# THE MEMPHIS DEPOT TENNESSEE

AR File Number 119

**EPA Comments**  
**Draft ROD for Interim Record of Decision**  
**of the Groundwater at Dunn Field-DDMT**  
**August 1995, CH2M HILL**

Table 6  
Maximum Effluent Standards for Discharge of Waste into the Municipal Sewerage System

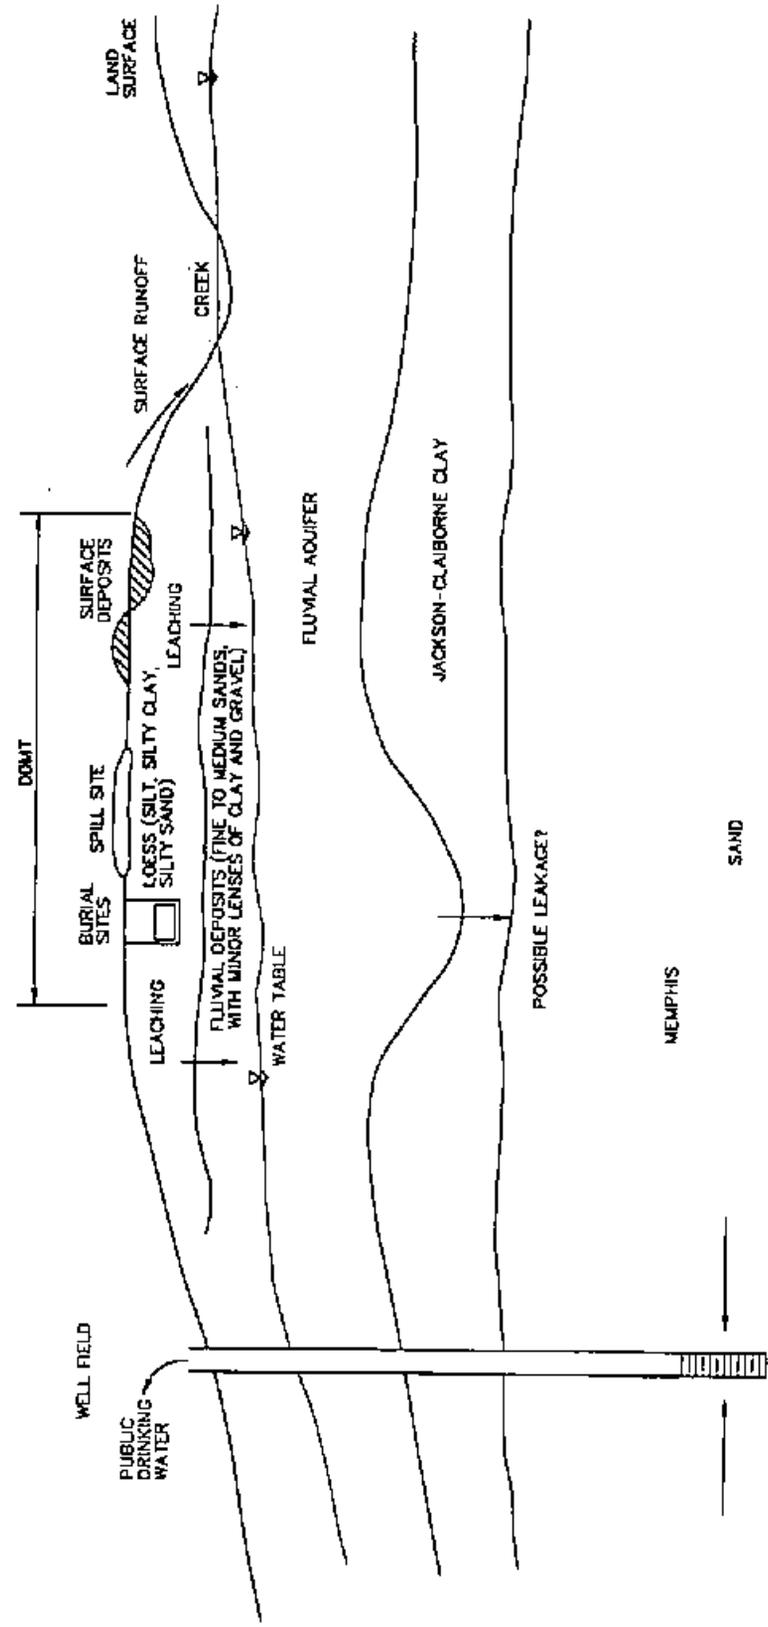
15	Section 2.7.8, page 2-16, third bullet-The contents of this bullet need to be broken up into at least two sentences. As it is, it is rambling and somewhat confusing.	The third bullet is rewritten into two sentences as follows: "After the aquifer characteristics are established and the leading edge of the plume is identified, additional groundwater recovery wells will be installed as appropriate to contain the plume. These wells are located along the leading edge of the plume and screened in the Fluvial Aquifer down to the confining clay layer of the Memphis Sand Aquifer."
16	Section 2.9, page 2-28, bulleted paragraph at bottom of page-Syntax between the initial phrase and the last three bullets appears to be incorrect.	Syntax has been corrected.
17	Section 2.9, page 2-29, first paragraph, last sentence-"Table 4 . . ." should be "Table 5 . . ."	With the addition of a new table, both the reference to the table and the table on page 2-29 are changed to read Table 6. The table of contents is also corrected.
